DESIGN REVIEW BOARD NOVEMBER 17, 2017

DESIGN REVIEW BOARD SUMMARY

2. DRB170055 Volvo 1575 Mansell Rd

Sheet Title:
Site Plan

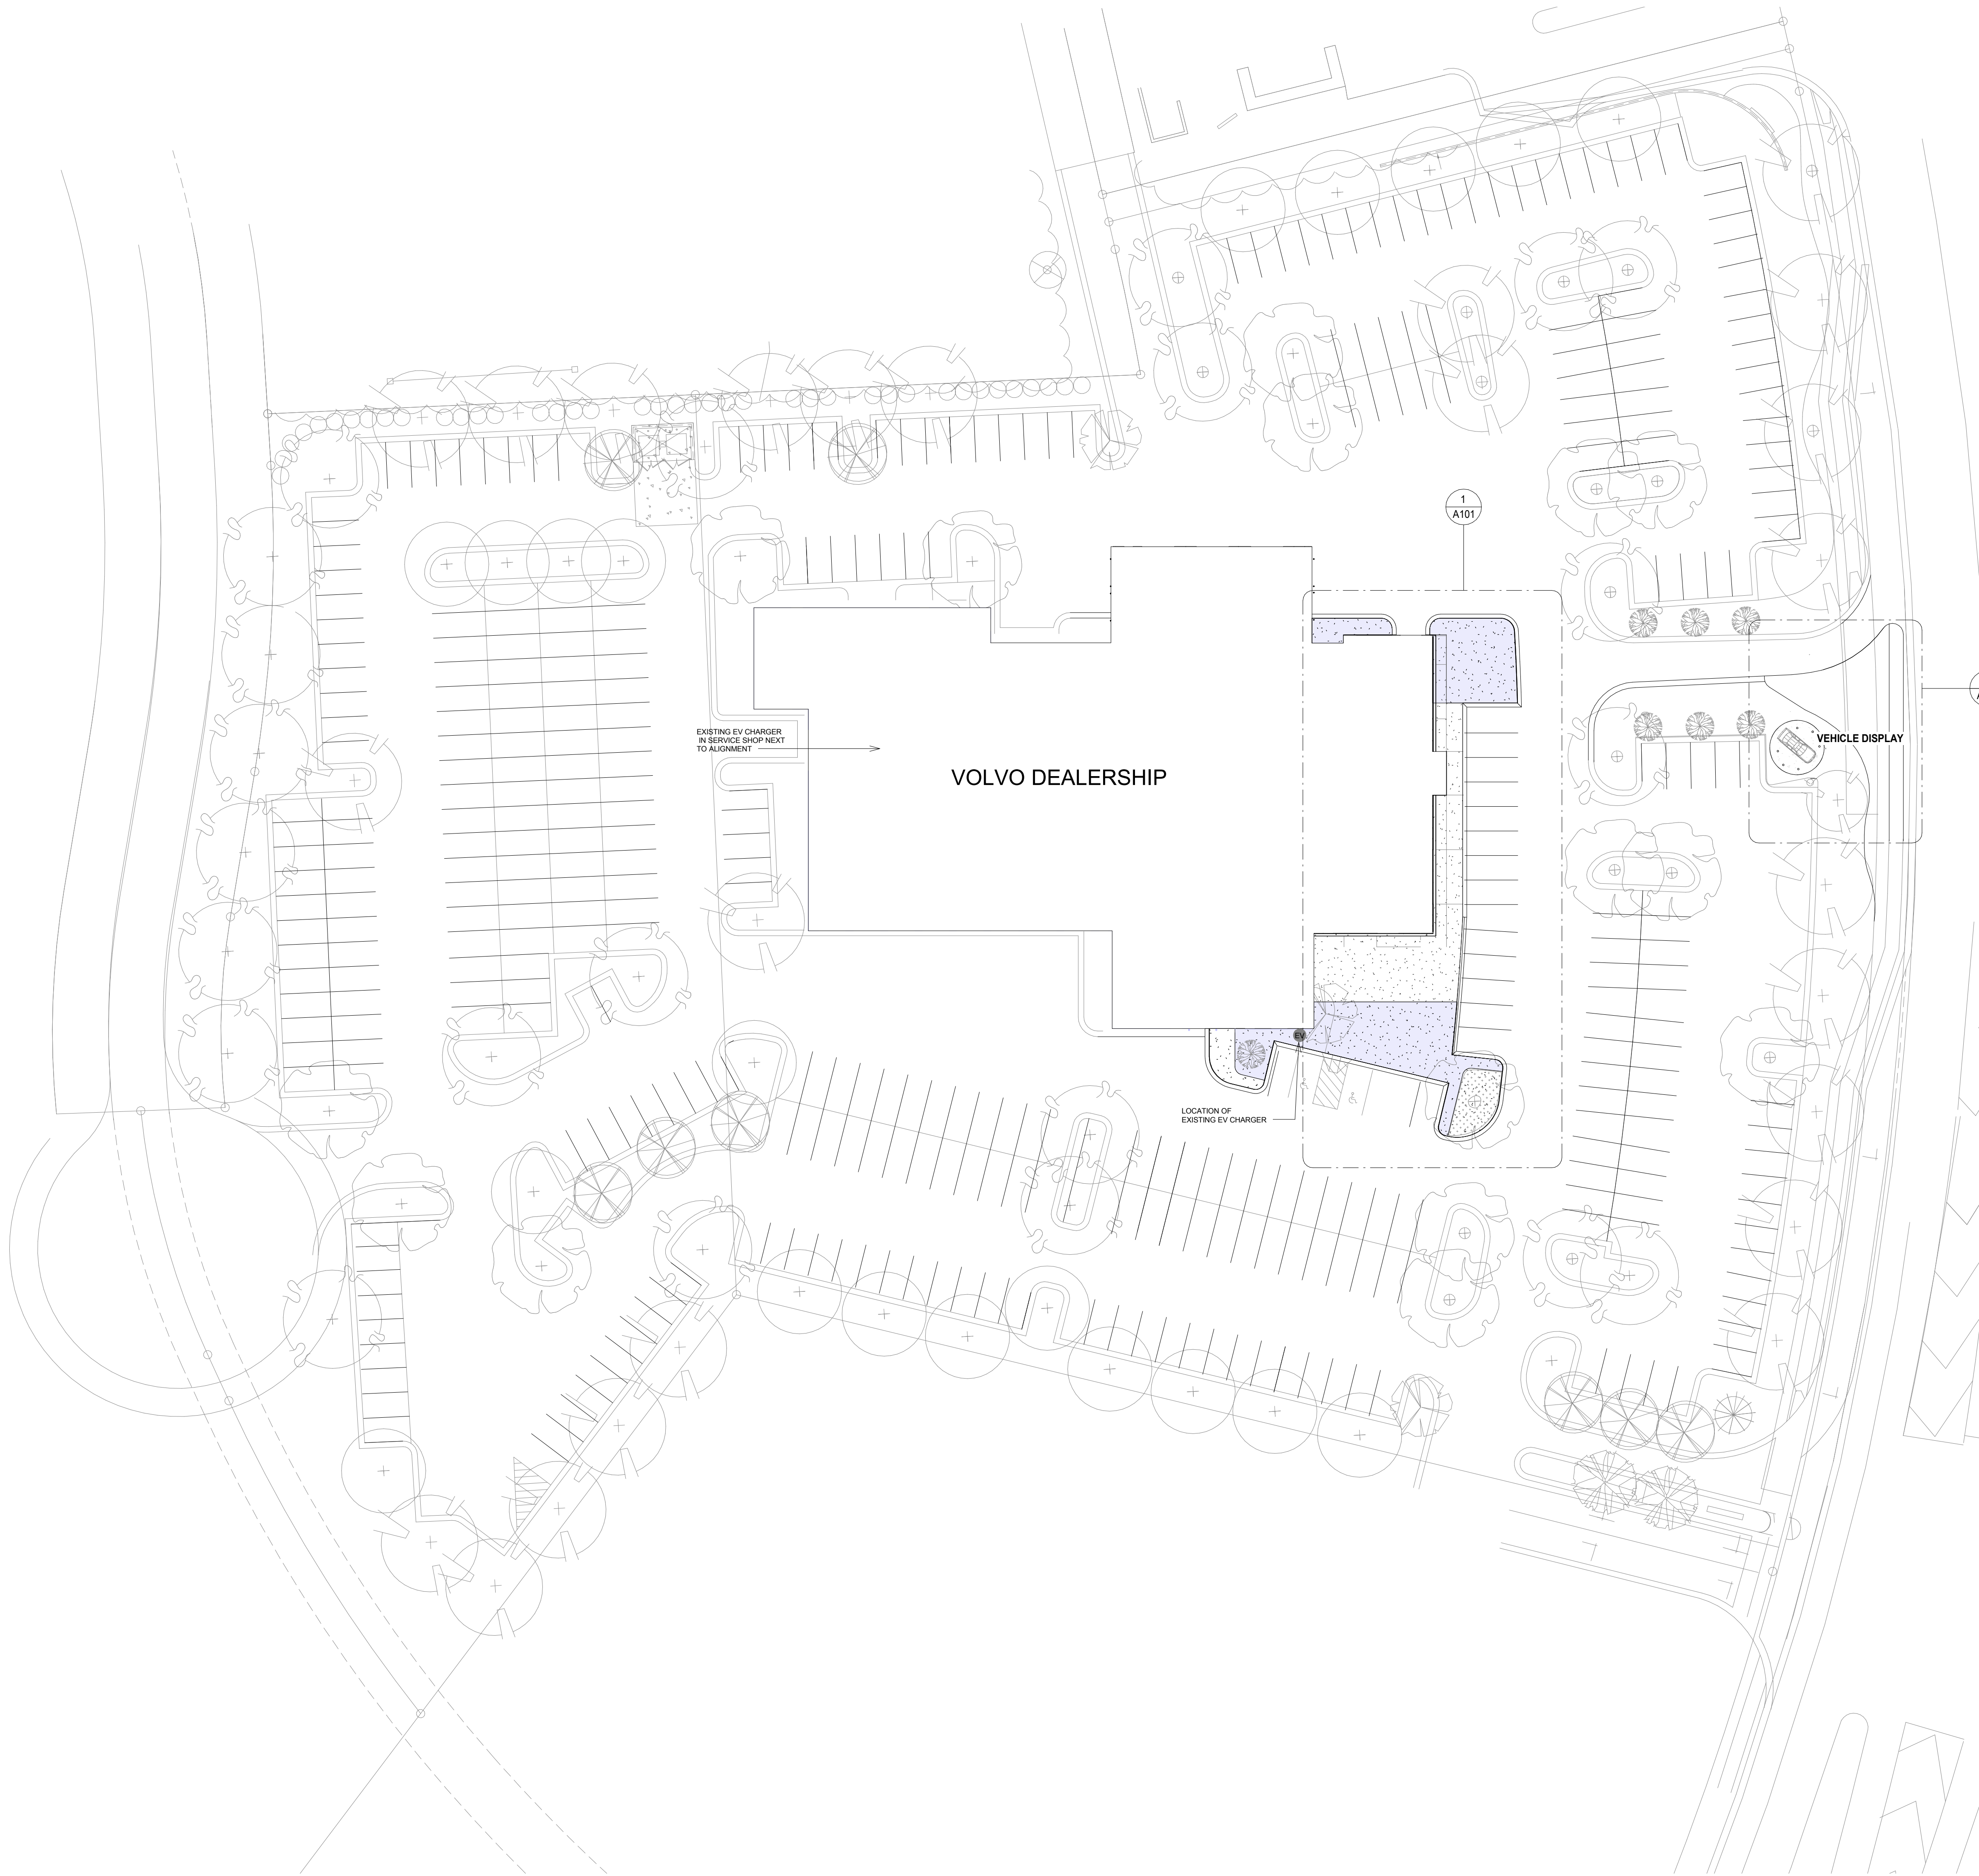
- Applicant stated it is intended to be a Scandinavian design with minimal façade.
 - DRB was concerned of pure amount of hardscape in front of building. Requested that Applicant relook at landscape and existing tree.

- Applicant discussed low-lying plants in front of buildings and clear glass.
-
- Addition of parking. Staff stated Applicant is not adding impervious surface. They are removing the canopy that is already concrete and putting parking spaces there.

COMPARISON OF LIGHTING CONDITIONS AT NIGHT FOR SIMILAR FACILITIES IN ALPHARETTA

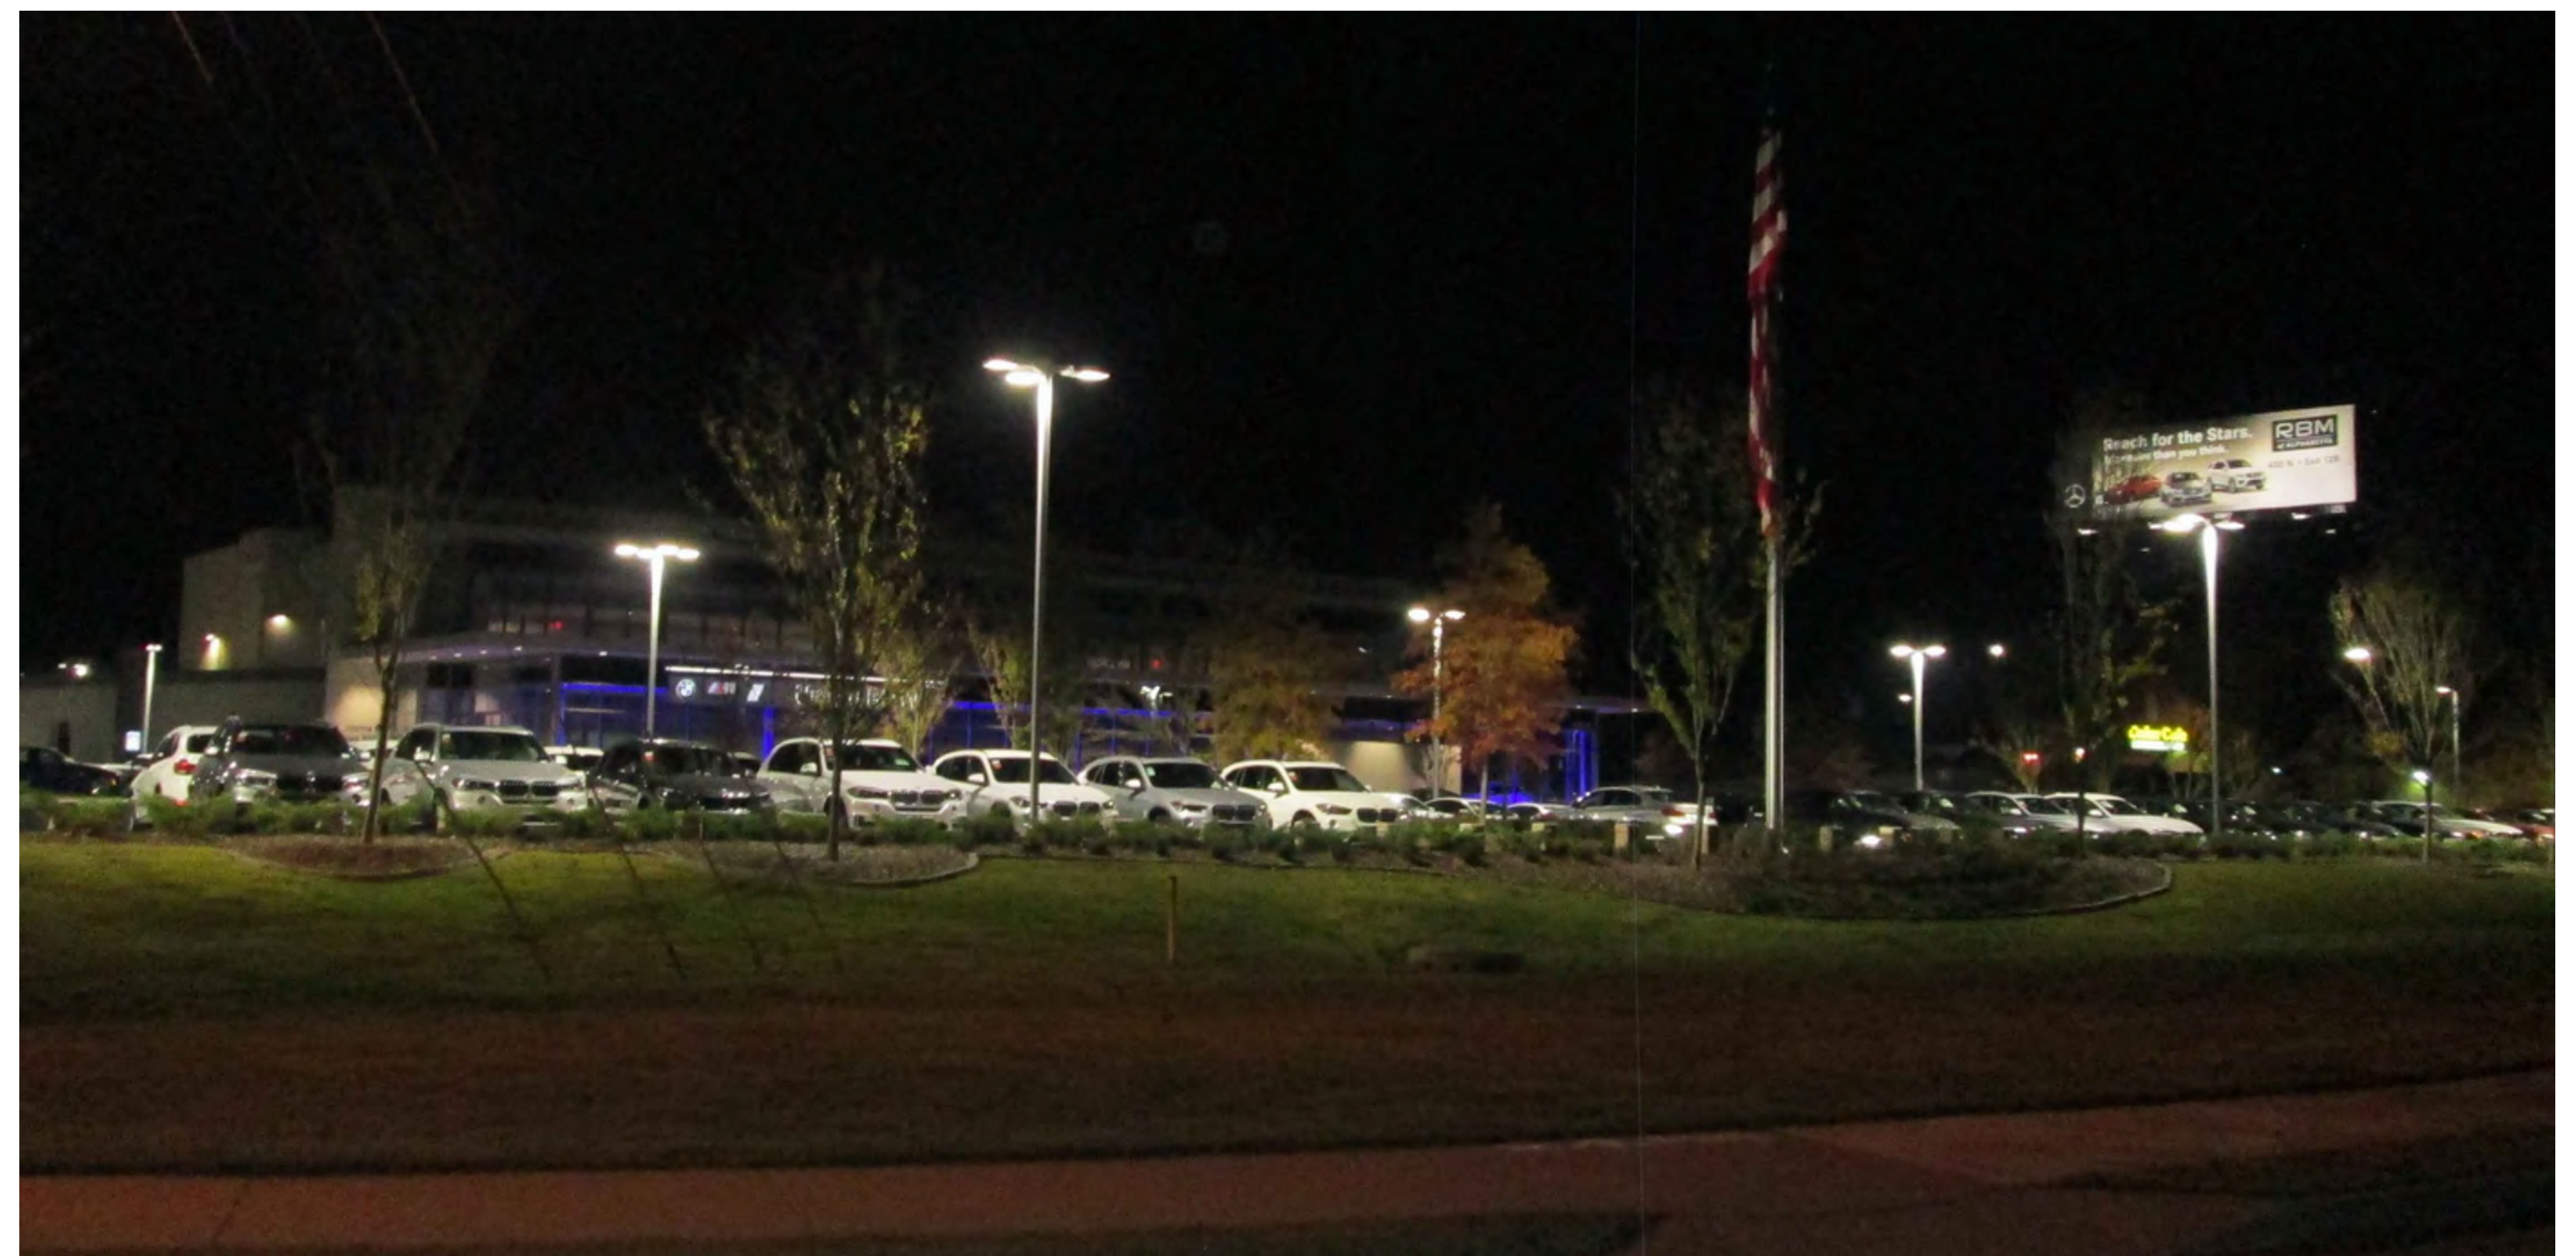
- Site Plan
 - Demo Plan
 - Backlit Lighting of Opaque Glass Panels with one exception of “gap” in parapet, which will be lit. DRB viewed examples of other locations.

- o Uniformity look of glass
 - o Reflectivity
 - o Night time Look
 - o Concern of “glowing box”
 - Need for Architectural Elements to add more detailing in a vertical sense

- o May need metal panels
 - o EIFS
 - o ACM panels
 - Applicant would prefer to reduce glow perception with lighting levels other than changes of materials. Fixtures are dimmable.
